**MONTGOMERY COUNTY PLANNING DEPARTMENT**  
 THE MARYLAND-NATIONAL CAPITAL PARK AND PLANNING COMMISSION

**MEMORANDUM**

**REVIEW TYPE:** Preliminary and Site Plan Review  
**CASE #:** 120050060 and 820070100  
**PROJECT NAME:** Ashton Meeting Place

**RECOMMENDATION:** Denial of the Preliminary Plan and the Site Plan.

FIGURE 17

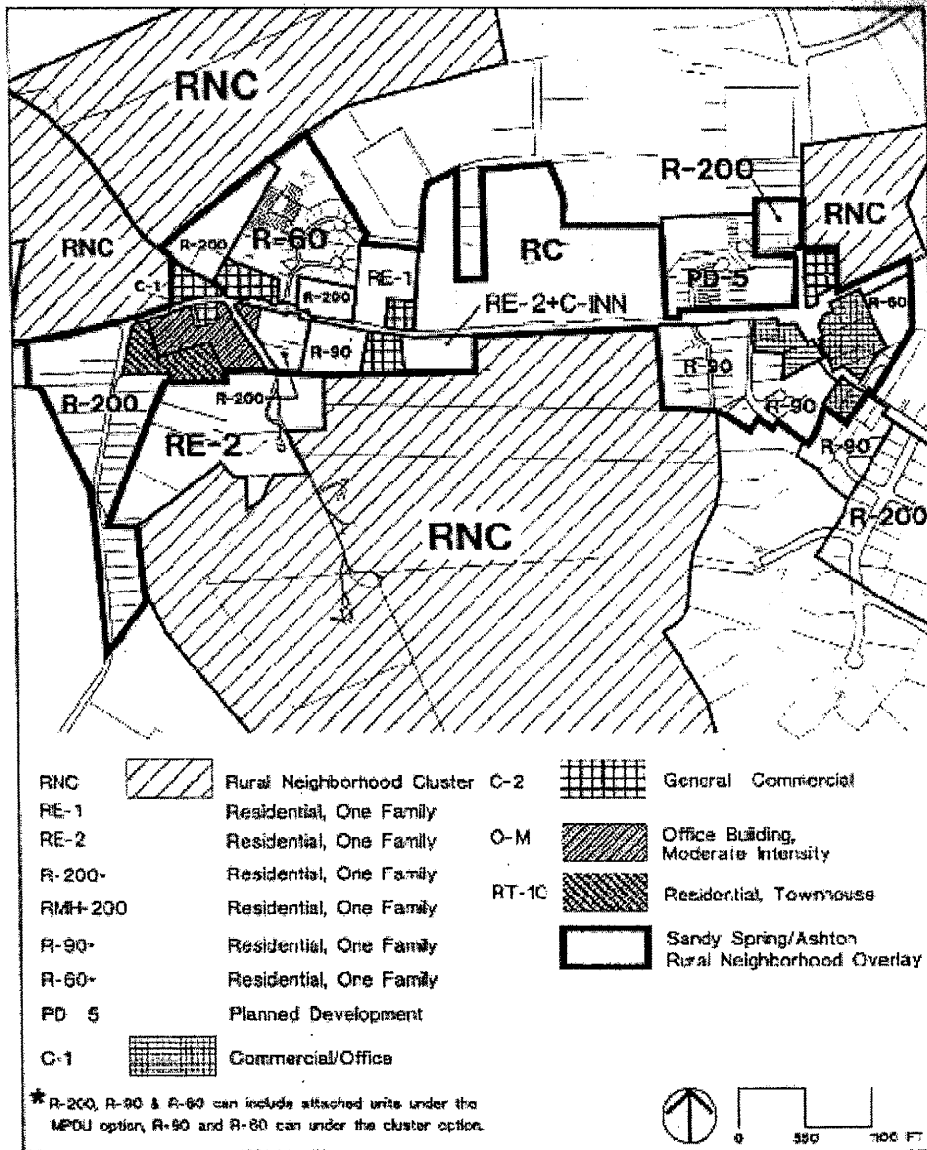
There is a more substantial problem with Zoning Ordinance section 59-C-18.184(b), which requires that any proposed development must “substantially conform with the design guidelines” in the master plan. In this case, there are several reasons why this finding cannot be made. There are several design guidelines specifically mentioned in the master plan:

# C. Preliminary Plan

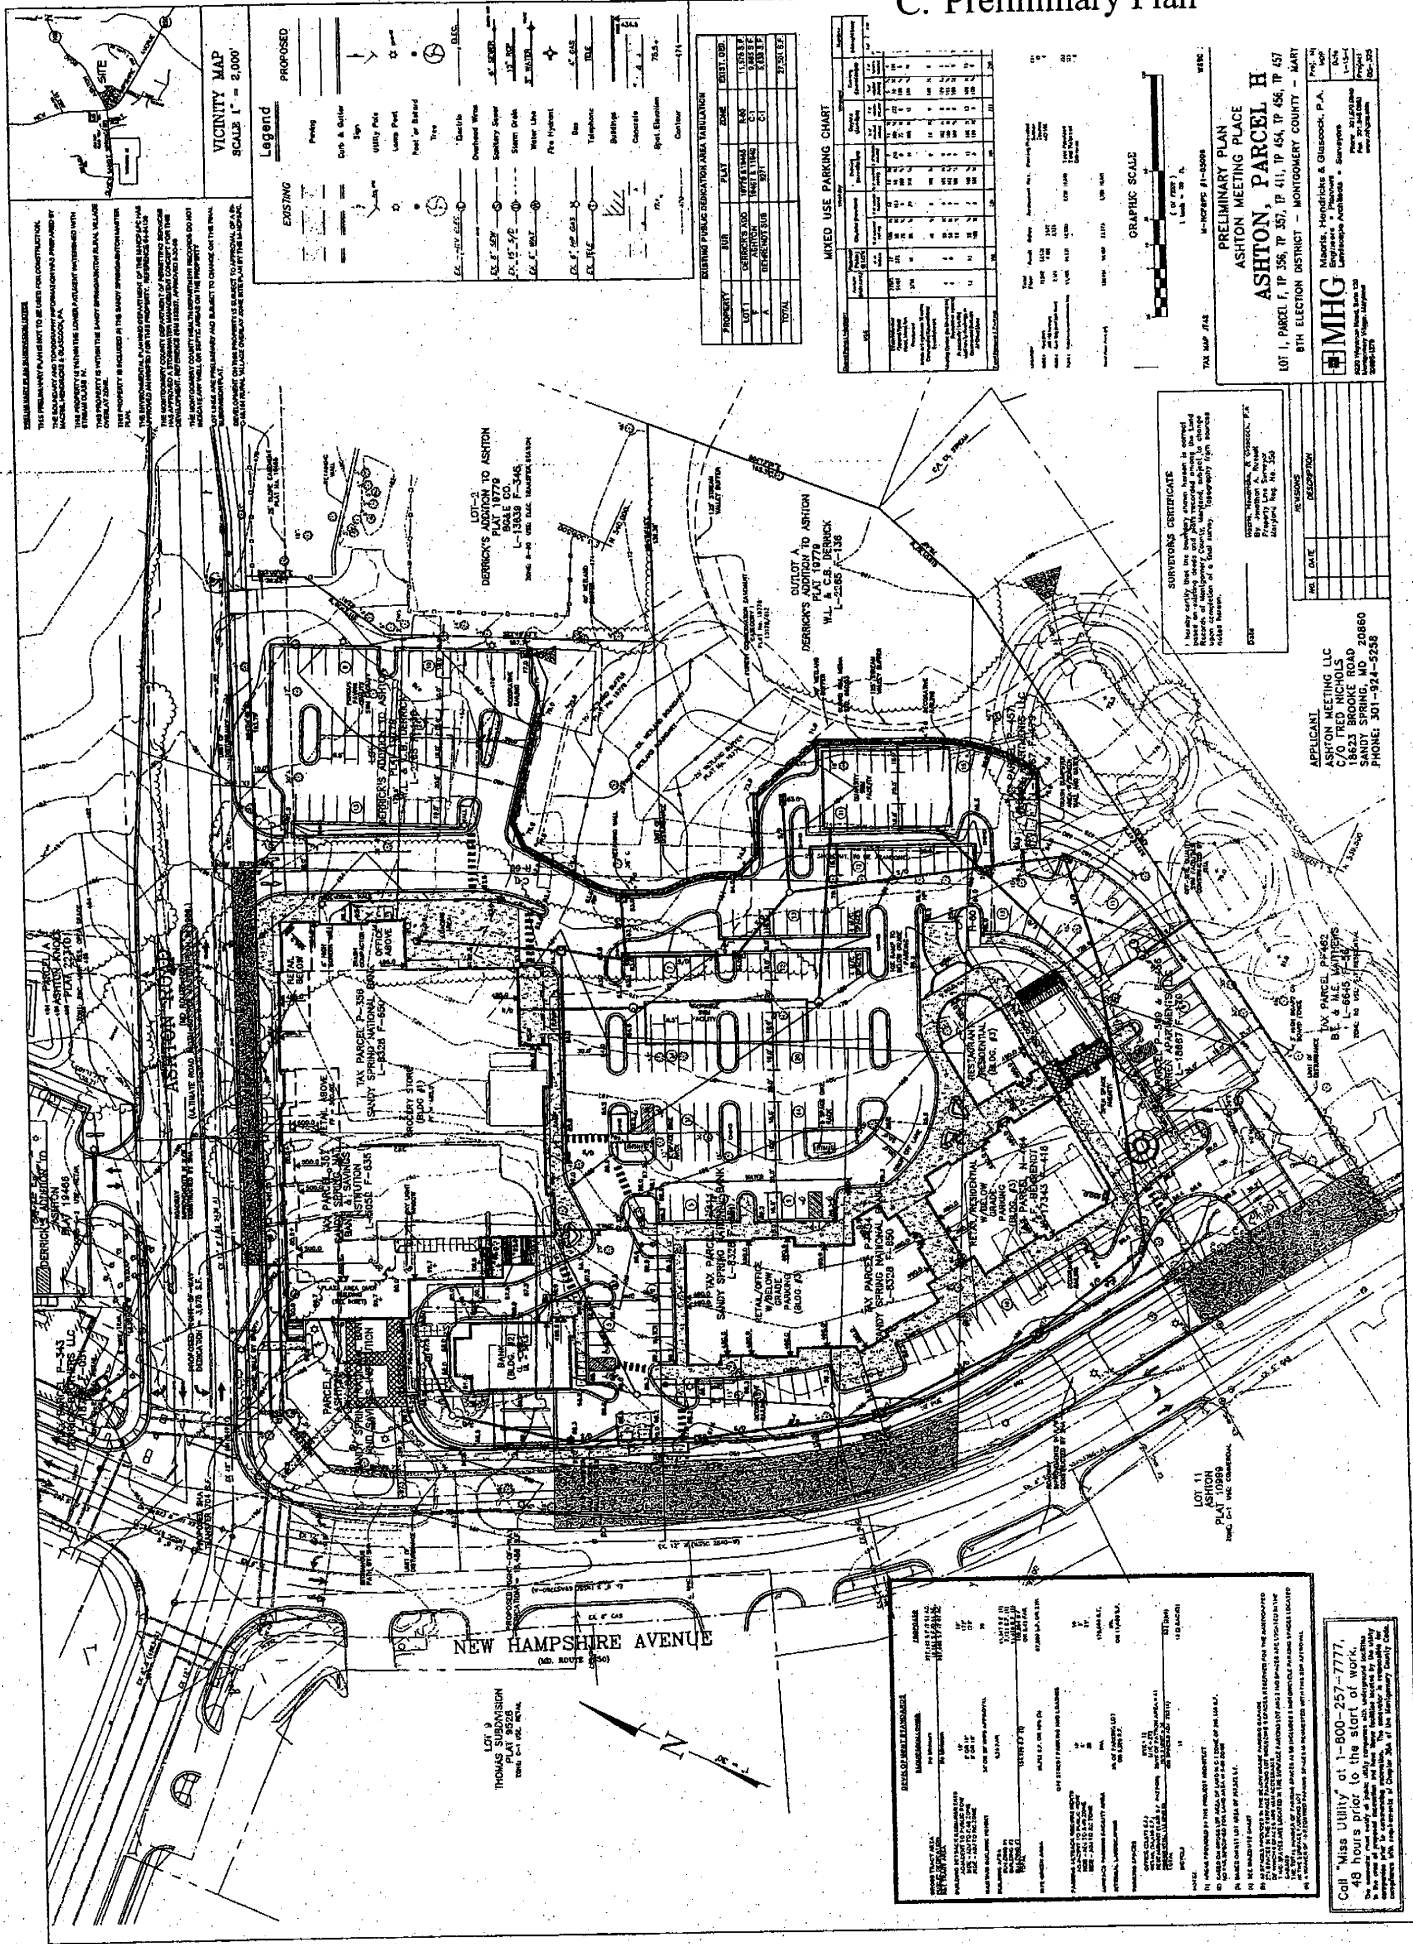
Staff concludes that preliminary plan 120050060 does not comply with certain sections of the Montgomery County Zoning Ordinance and sections of the Subdivision Regulations. Specifically, the plan fails to comply with Sections 59-C-4.2 and 59-C-18.18 of the Zoning Ordinance, both of which affect the ability to provide adequate parking on the project. Because the project continues to encroach into wetlands, wetland buffers, and stream buffers with what staff believes to be otherwise avoidable encroachments, staff contends that the plan does not comply with Section 50-32(c) of the Subdivision Regulations which require protection of environmentally sensitive areas.

# D. Site Plan

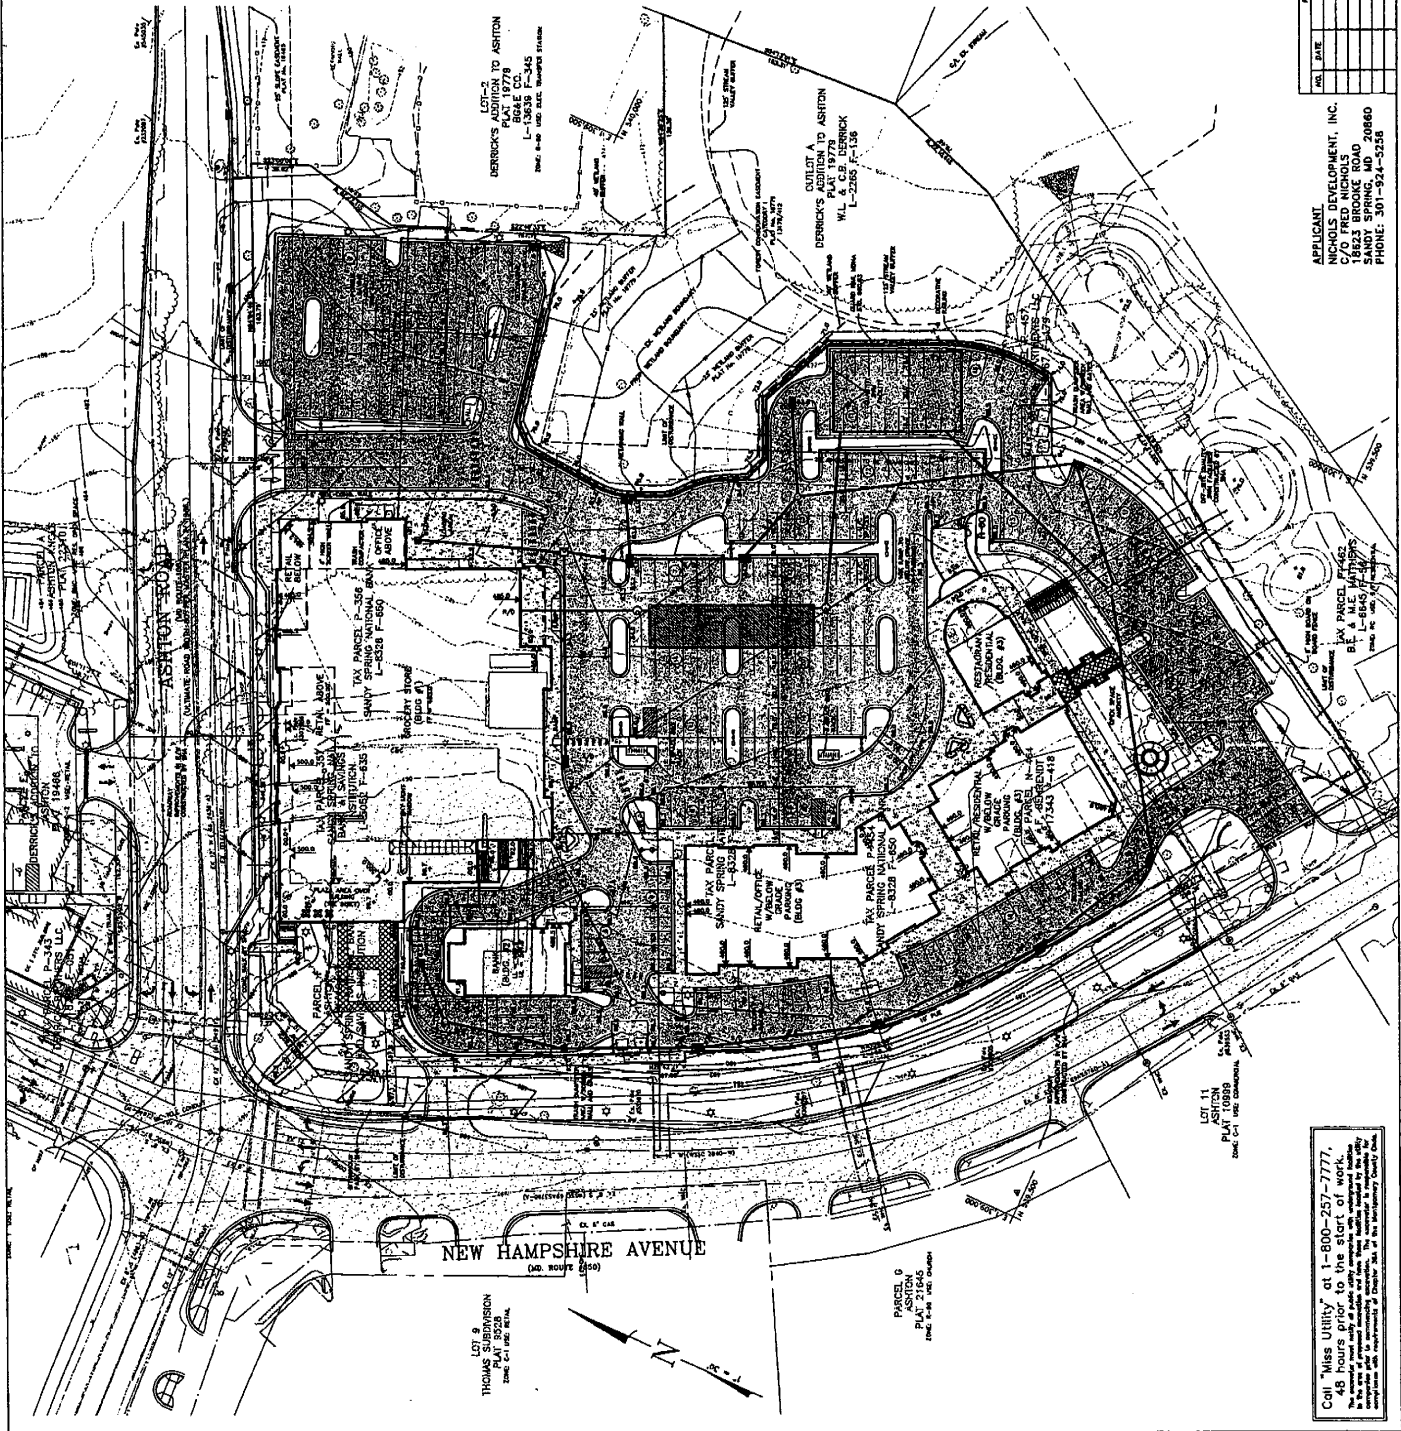
Staff also concludes that site plan 820060230 does not substantially conform with the design guidelines for new development contained in the approved and adopted Sandy Spring/Aston Master Plan and is not wholly consistent with the Master Plan recommendations. The location of the buildings and structures is not safe and efficient and the plan as proposed is not compatible with the rural village concept.

For all of these reasons, the development shown on the plan is too intense for this property and is recommended for denial. A future plan with less density should be able to comply with the parking limitations, avoid the environmentally sensitive wetlands and buffers on the site, and be more in keeping with the intent of the Rural Village Overlay Zone.
